PROJECT: PORTAL WAY OVERLAY PROJECT
CITY PROJECT NUMBER ST2015-07

ADDENDUM NO. 1
To the Contract Provisions for
CITY OF FERNDAL, WASHINGTON

PORTAL WAY OVERLAY PROJECT
CITY PROJECT NUMBER ST2015-07

10

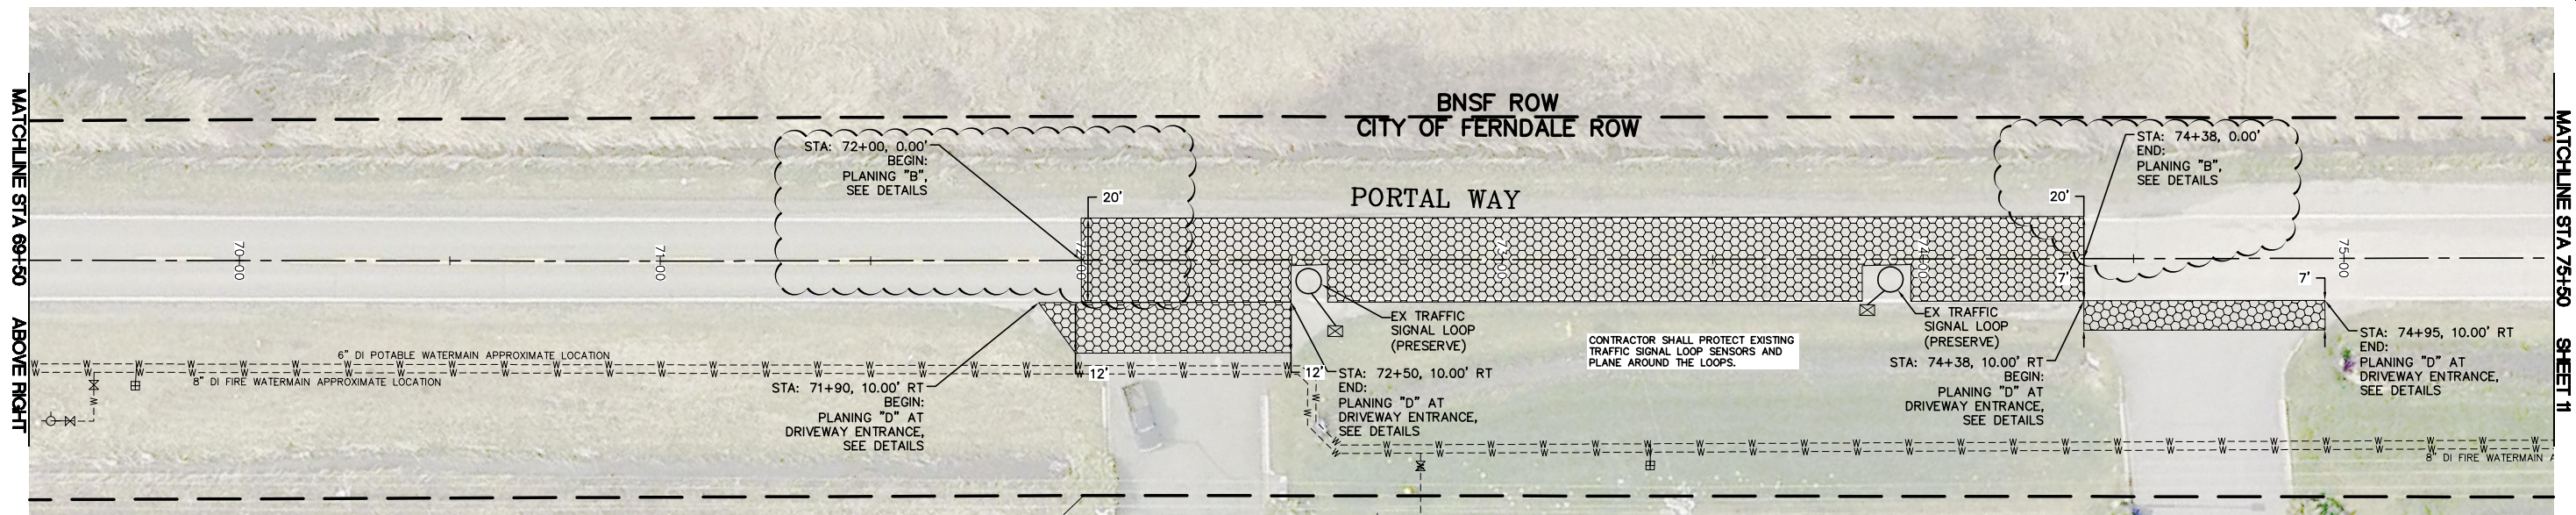
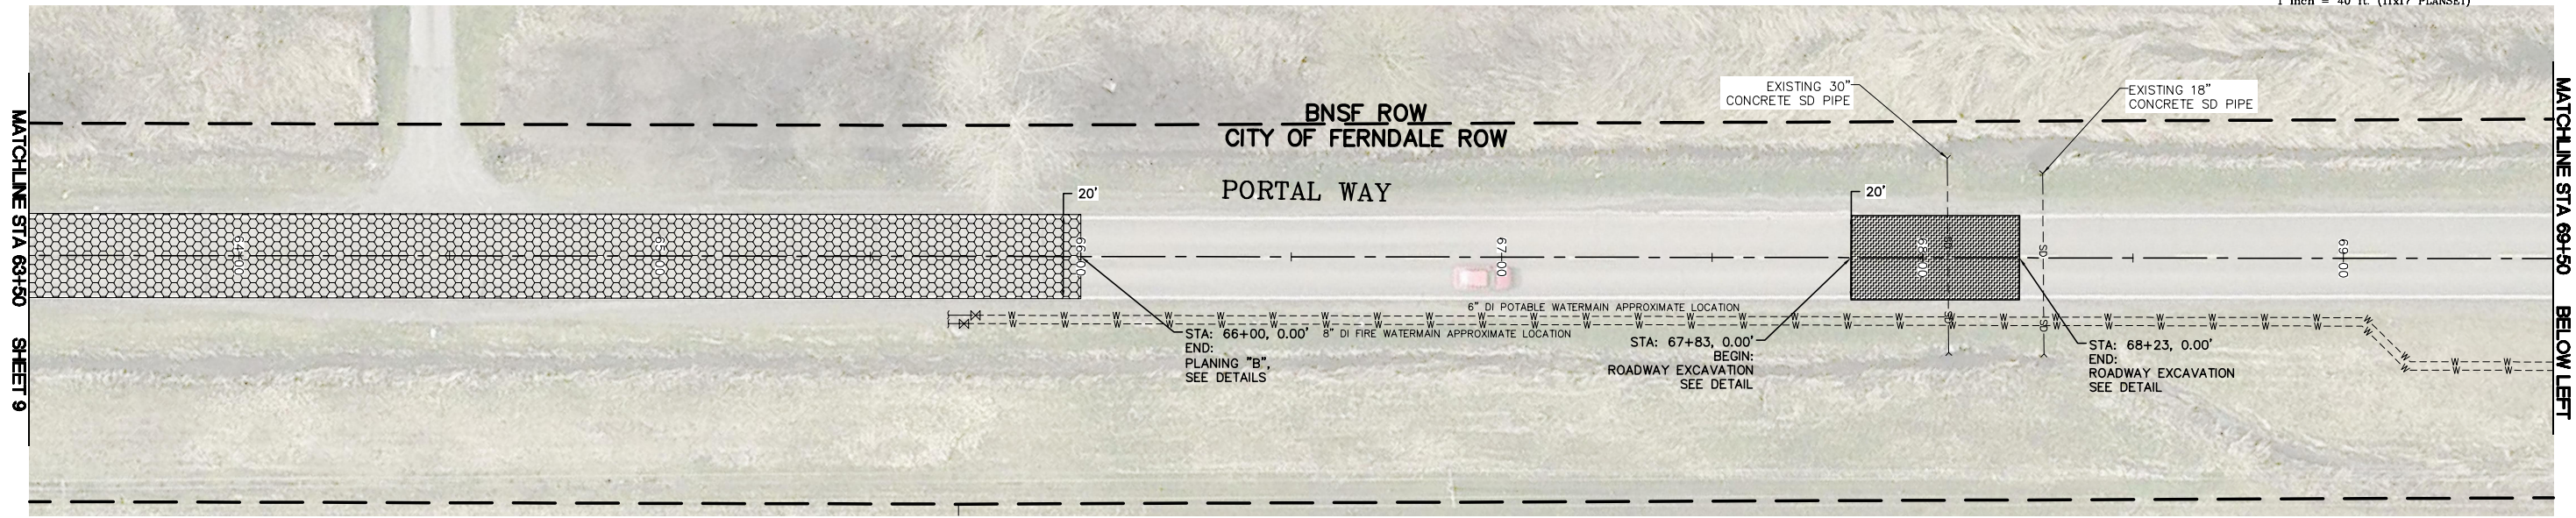
Plan Sheet 10

The type of planing and dimensions are noted on the Plan Sheet.

DATE 3/17/17
SHEET 19
of 22

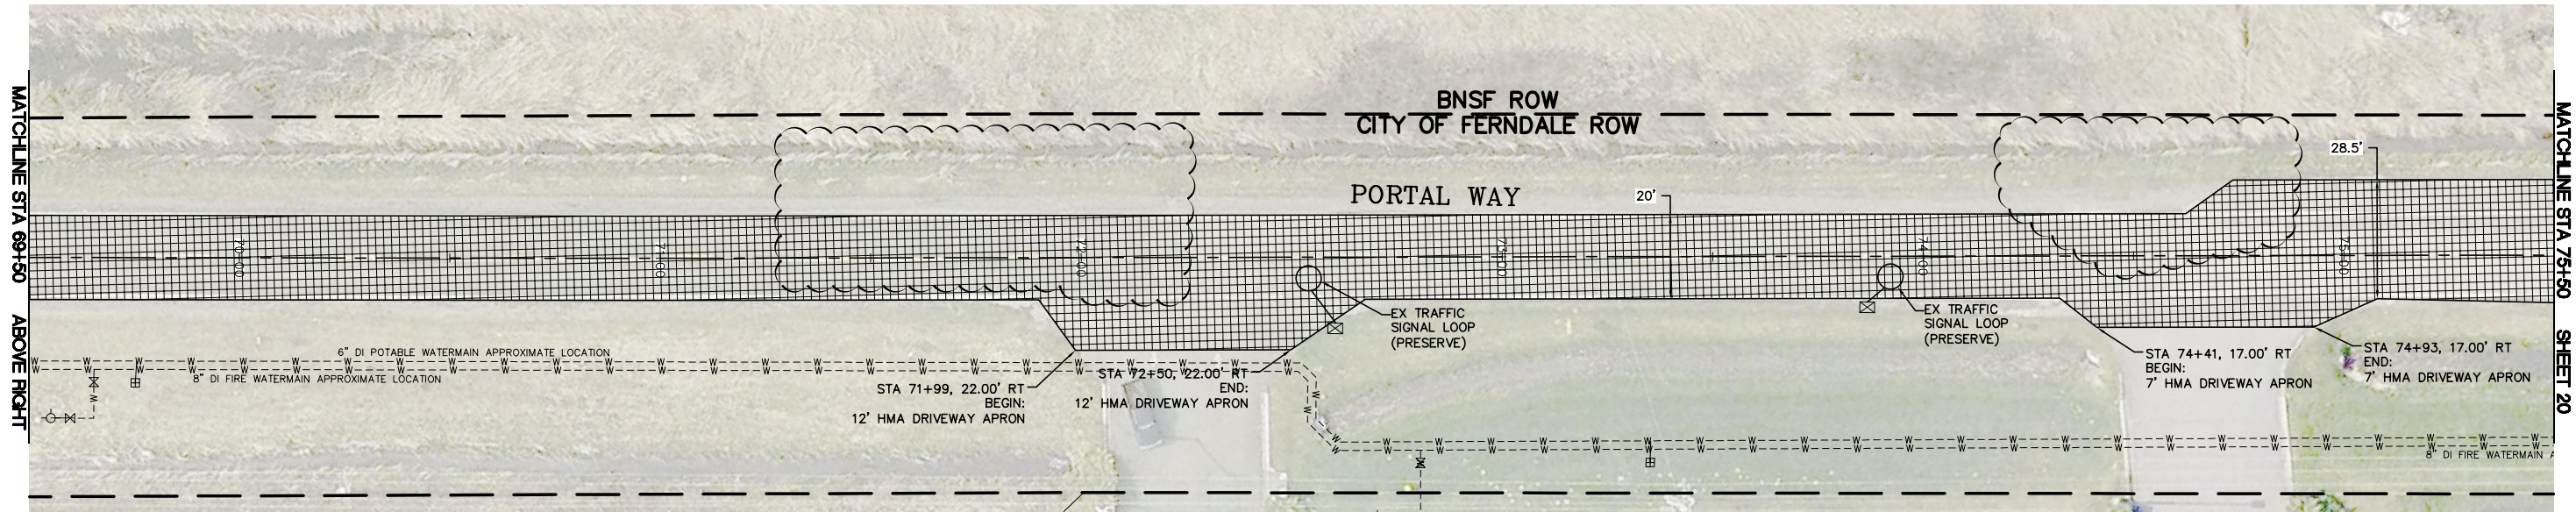
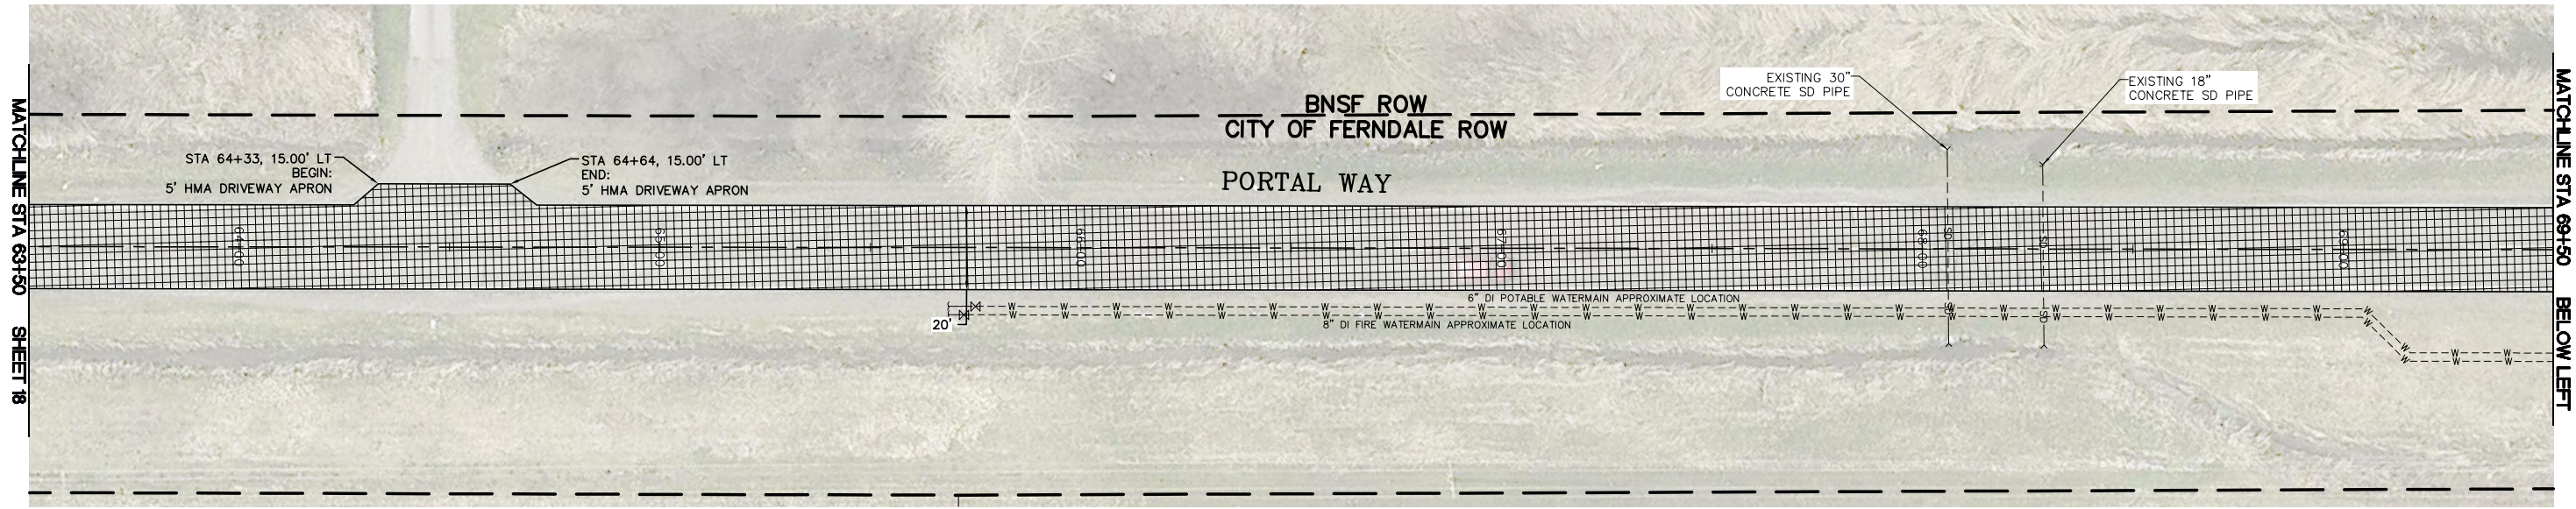
Plan Sheet 19

The text calling out the type of planing was deleted as this is a paving plan sheet.
